# Access Compliance Report

## Public Rights-of-Way

### (Curb Ramps)

Intersection ID: 20185	Main Street: FAIRVIEW_RD	Cross Street: PIEDMONT_ROW_DR	Location: NE
ADA ID: 59279713E568	Ramp Type: Perp	Initial Pass/Fail: Fail	Overall Compliance: No
Severity Score: 12.5			
Codes/Mitigation Info/Possible Solution		Field Measurements/Component Compliance

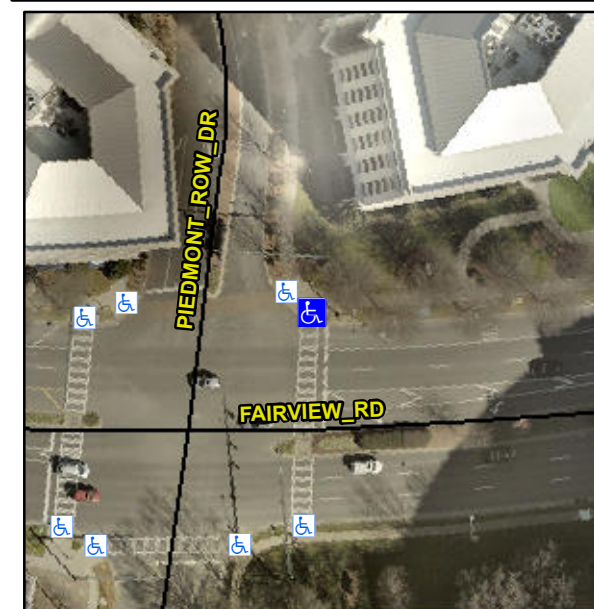
**Remove & Replace Entire Ramp.**

**R304.2.2**

Compliance	Description	Data	Compliance	Description	Data
N/A	Ramp Length (in)	96.0	No	Ramp Slope (%)	11.0
Yes	Ramp Width (in)	48.0	Yes	Ramp XSlope (%)	2.0
N/A	Flare Type LT	N/A	N/A	Flare Type RT	N/A
N/A	Flare Slope LT (%)	N/A	N/A	Flare Slope RT (%)	N/A
N/A	Flare Traversable LT?	N/A	N/A	Flare Traversable RT?	N/A
N/A	Landing Length (in)	N/A	N/A	DWS Provided?	N/A
N/A	Landing Width (in)	N/A	N/A	DWS Contrast?	N/A
N/A	Landing Slope (%)	N/A	N/A	DWS Length (in)	N/A
N/A	Landing X Slope (%)	N/A	N/A	DWS Full Width?	N/A
N/A	Landing Curb? (Y/N)	N/A	N/A	DWS Offset (in)	N/A
N/A	Shared Landing?	N/A			
N/A	Gutter Ponding?	N/A	N/A	Gutter Slope (%)	N/A
N/A	Gutter Lip Ht (in)	N/A	N/A	Gutter X Slope (%)	N/A
N/A	Painted X Walk1?	Yes	N/A	Painted X Walk2?	N/A
	X Walk 1 Direction	To SW		X Walk 2 Direction	N/A
N/A	X Walk 1 Width (in)	93.0	N/A	X Walk 2 Width (in)	N/A
	X Walk 1 Slope (%)	3.6		X Walk 2 Slope (%)	N/A
	X Walk 1 X Slope (%)	1.6		X Walk 2 X Slope (%)	N/A
